SMITTYBILT TECHNICAL UPDATE

SM-03.21.2016

APPLICATION 11-16 JK

PART NO. 76903/76904

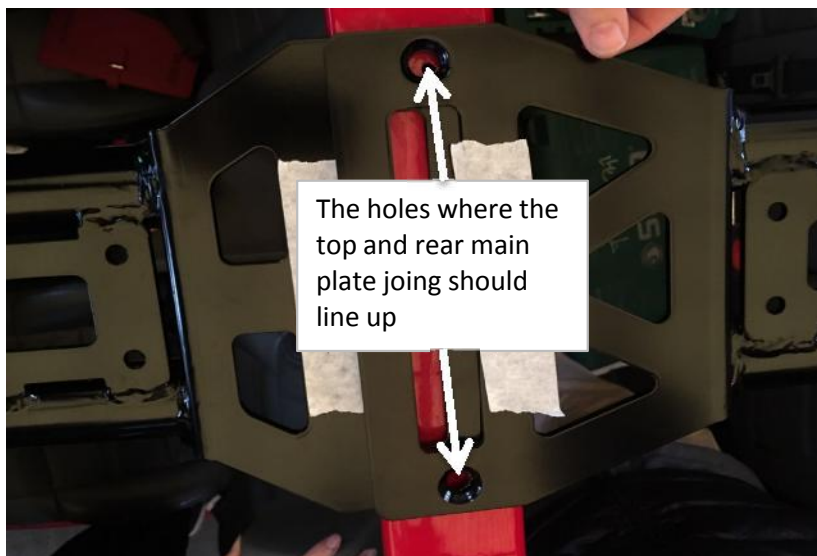
When the front top cross bar is in the correct location the holes in the rear and front main plate may not line up, so you will need to slot the holes on the rear section of the top front main plate.

The front top cross bar should be as far forward as possible, up against the weld of the O.E. sport cage.

Before drilling make sure the holes of the rear and front top main plates line up correctly.

If the holes do not line up, slot the holes towards the back, or drill a new one.

The holes where the top and rear main plate joining should line up

A. The slots on the rear of the top main plate are now being slotted longer in order to make sure they will line up.
